SPECIAL MEETING OF THE LADY LAKE TOWN COMMISSION

SUBJECT: Conceptual Presentation for the Citizen's First Bank Drive-through Facility Major Site Plan - MJSP 07/14-001- A Development consisting of a 330-square-foot Financial Institution Building with the provision a Three-Lane Service Drive-Through Facility proposed at 1105 Caballero Court (AK 3840565).

Proposal: New Major Site Plan No. 07/14-001 Application– 1st Round of Comments for Site

RE: CITIZENS FIRST BANK DRIVE THRU- MJSP 07 14-001 - SITE PLAN
RAI #1 (FBA#921141.3223)

Site Lighting Plan

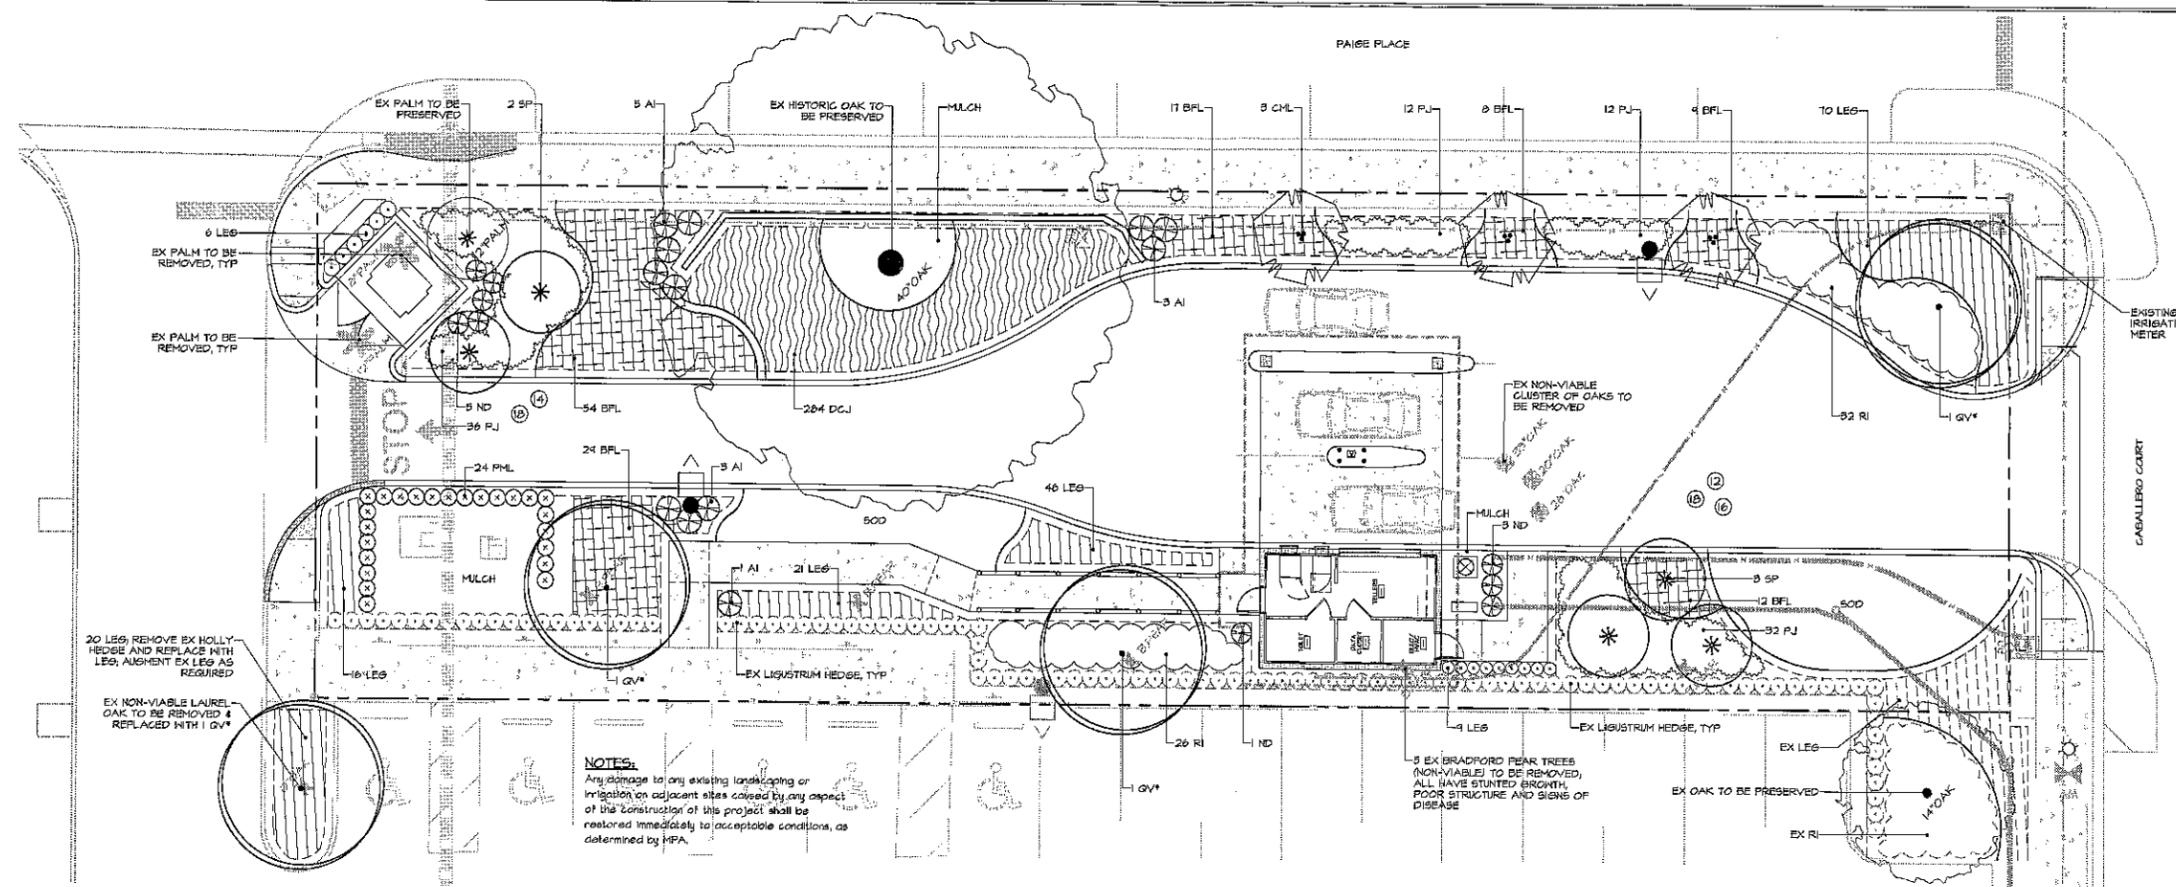
1. The Site Lighting Plan should indicate light levels achieved through fixtures called for in the plans. Analysis should take into consideration the substrate which light is hitting i.e. concrete vs asphalt. There is one isometric line shown for each light but no indication of light values for those individual isometric lines. Isometric lines may be utilized, but intervals of isometric lines should be shown and labeled. The current plans isometric line showing dispersal of light does not appear to take into account adjacent light effects. To give an accurate representation of light levels, illuminance values should be given in foot-candles through points at regular intervals over the site's sidewalks and travel ways. Additionally in photometric analysis; typically values are shown in a schedule of the sites average, minimum and maximum illuminance in foot-candles as well as the ratio of average/minimum and a max/minimum ratio of illuminance. The aforementioned information verifies proper light levels are planned for and gives the contractor light levels he should achieve in construction.

S:\LAKE\SITE PLANS\Spanish Springs\Town Center\CITIZENS FIRST BANK DRIVE THRU SITE.dwg, 8/22/2014 12:15:15 PM, BRP

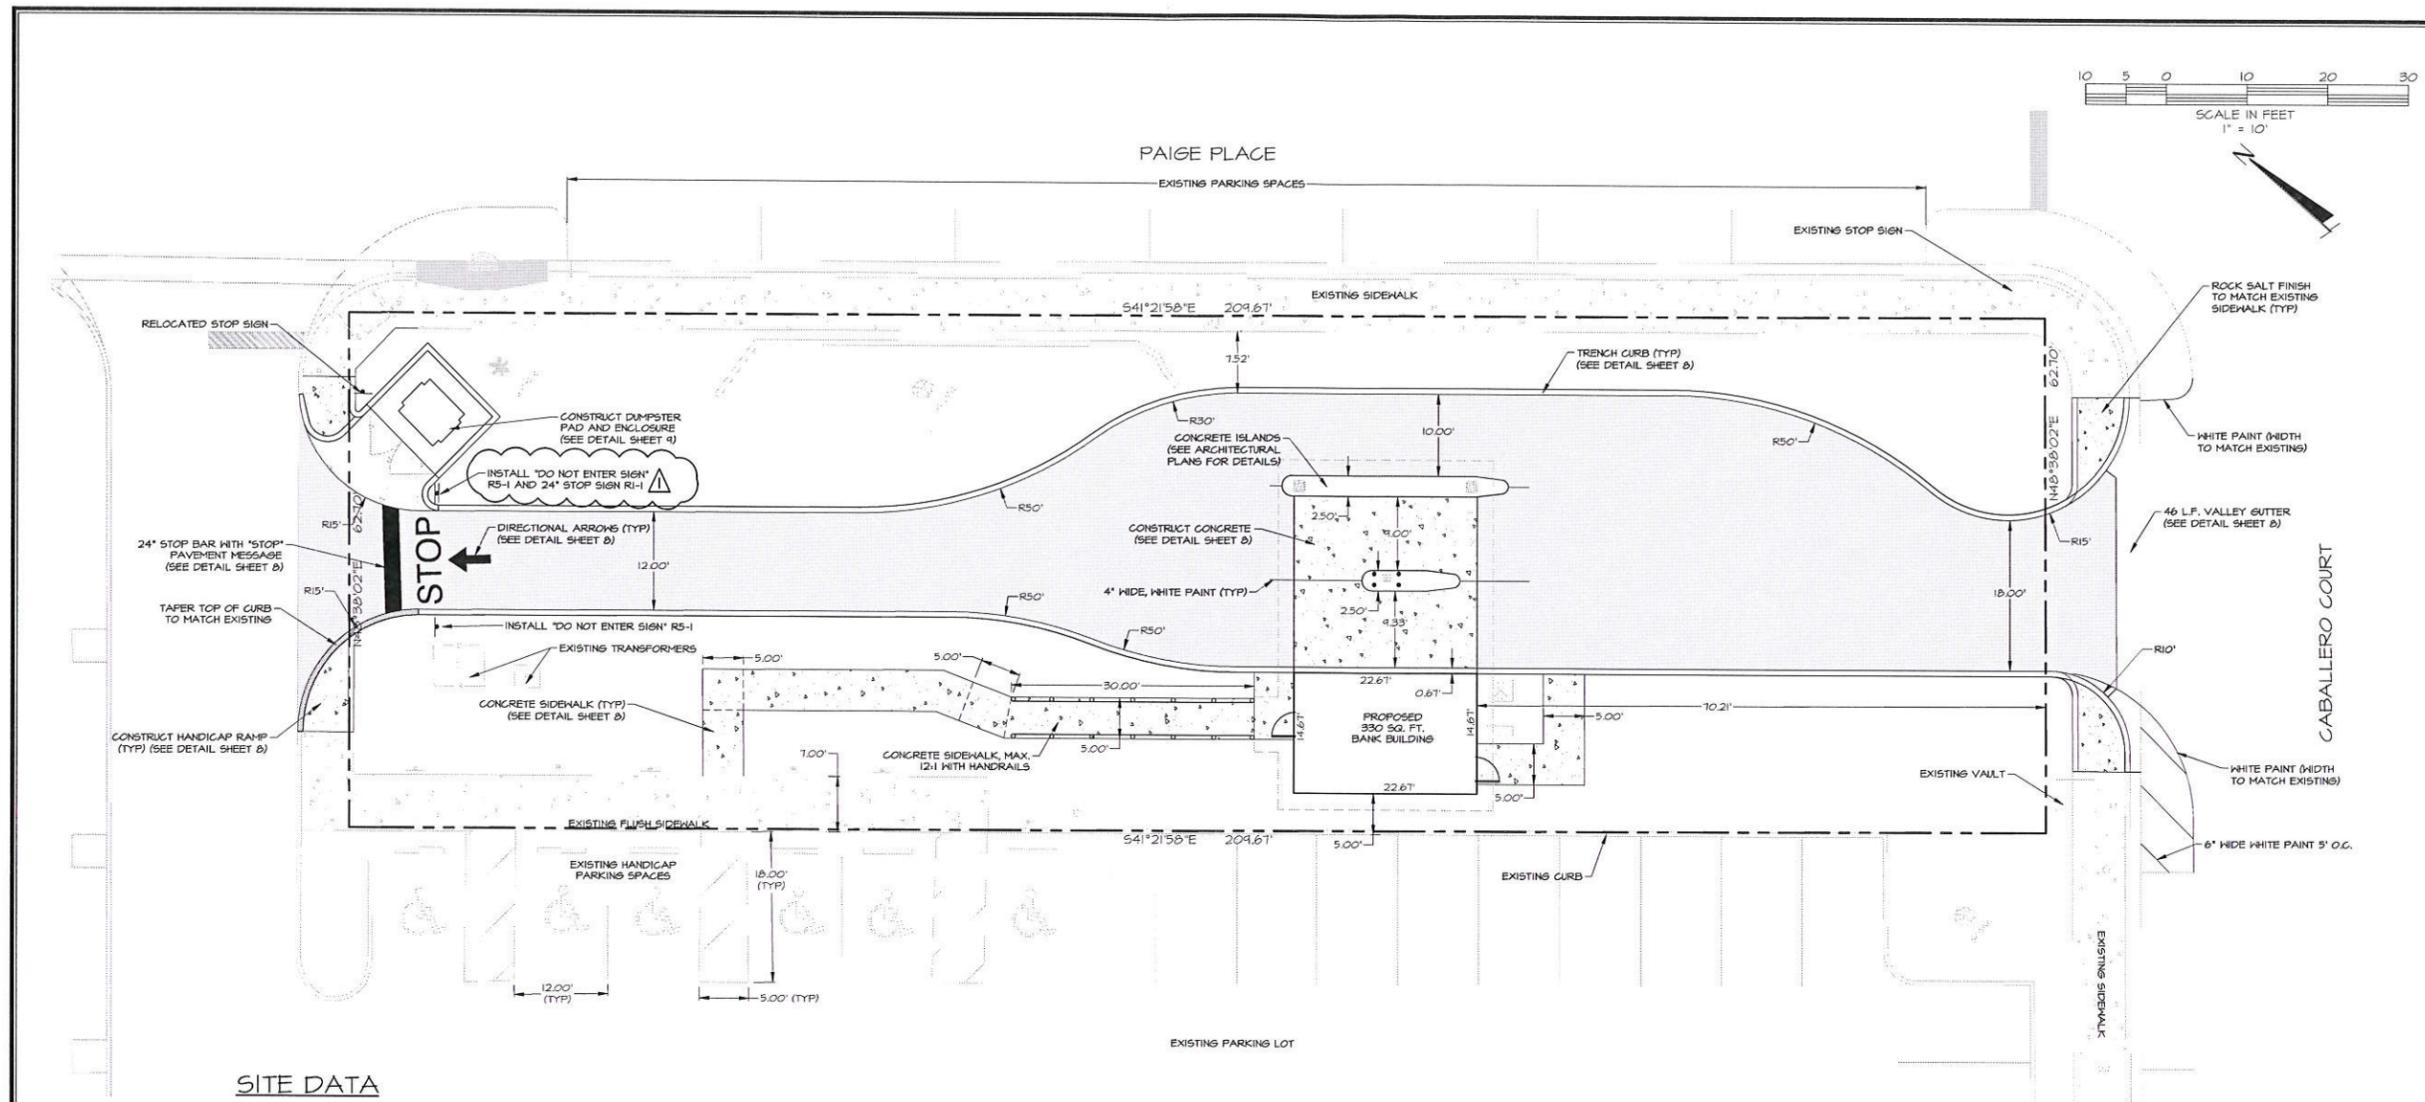
1. The site plan should reflect a "STOP" sign opposite the "Do Not Enter" plaque to the right at the property drive-thru exit. Per the Lady Lake LDCR Sec. 15-55 Part 3 "All legs of an intersection which are to be regulated in a stop condition shall include a stop sign and a stop bar". Per the Manual of Uniform Traffic Control Devices (MUTCD) Section 3B.20 Part 14 "Except at the ends of aisles in parking lots, the word STOP shall not be used on the pavement unless accompanied by a stop line and stop sign".

2. A street name sign should be reflected in the site plan as to be mounted atop the STOP sign indicated in the comment above. Per the Lady Lake LDCR Sec. 15-55 Part 3 "All intersections shall include street name signs, the location of which is to be identified on the construction plans".

1. After looking at the site plan it appears that the dumpster enclosure is too close to the road, meaning that while the truck is dumping the container the back of the truck would be in the right-of-way of the road.

- **Under Site Data (Sheet 5 of 9), please change zoning from PUD to CP-Planned Commercial.**

Response: Plans have been revised as requested.

Response: Street name sign is not needed as this is a parking lot driveway.

Response: No changes are needed per Mr. Beck since this is a parking lot driveway.

Response: Plans have been revised as requested.

Response: Traffic signage is shown on Site Plan, see sheet 5 of 9 of the plan.
